PREDEVELOPMENT PLAN REVIEW COMMENTS

Project Number: PPR2020-00002

Project Address: 50 Alessandro Place

Review of preliminary plans for the Revision of PD-5 by modifying the adopted PD Plan to facilitate construction of a three-story, 60,000 square-foot, medical office building and a five-level, above grade, parking garage with 321 parking space.

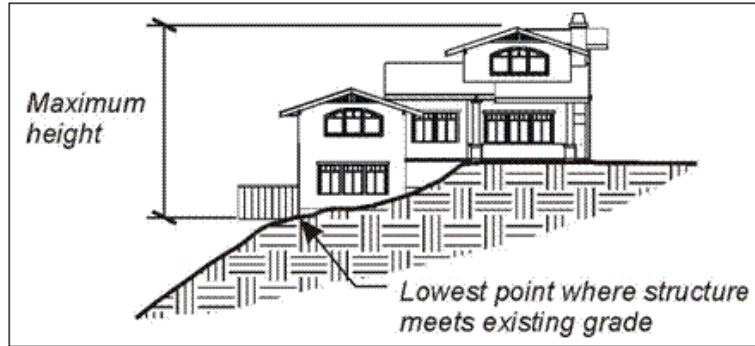
The project proposes a new medical office building with a height of approximately 52 feet, per sheet 6 of the plans, Axon & Section. As proposed the project does not comply and would require an amendment to PD-5. As indicated, there are several two-story residential buildings adjacent and abutting the project site. The proposed building is out of scale and character with the residential properties fronting on Hurlbut Street. It is recommended that the applicant explore alternative options to reduce the massing, revise the design and consider a less intrusive use.

The project proposes a five level parking garage and exceeds the two stories above grade height limit. As proposed the project does not comply and would require an amendment to PD-5 to maintain the proposed heights. The proposed garage structure would be abutting a multi-family zoned neighborhood on its southern boundary. The proposed garage is out of scale and character with the residential properties to the south. It is recommended that the applicant revise the plans to consider a less intrusive use on this portion of the site.

In future plan submittals, label the height of the building measured from the lowest elevation of the **existing grade** at an exterior wall of the structure to the highest point of the structure. The highest point of the structure shall be considered its highest ridge or parapet.
